CMC Review Memorandum

BLA # 125755

Subject: Container Closure Review

Drug Product(s) Name: Elivaldogene
autotemcel

Figure 1: Representative Drawing of (b) (4) Bag¹

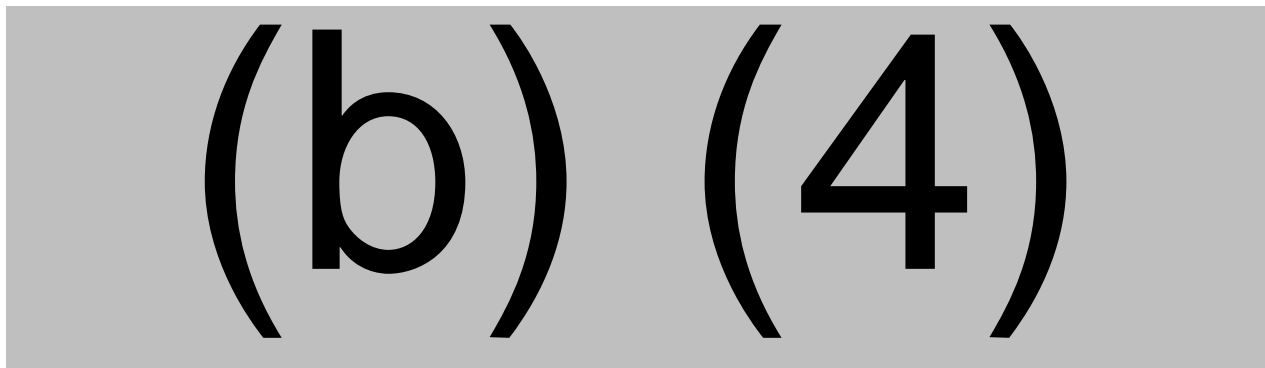
The container closure description is acceptable.
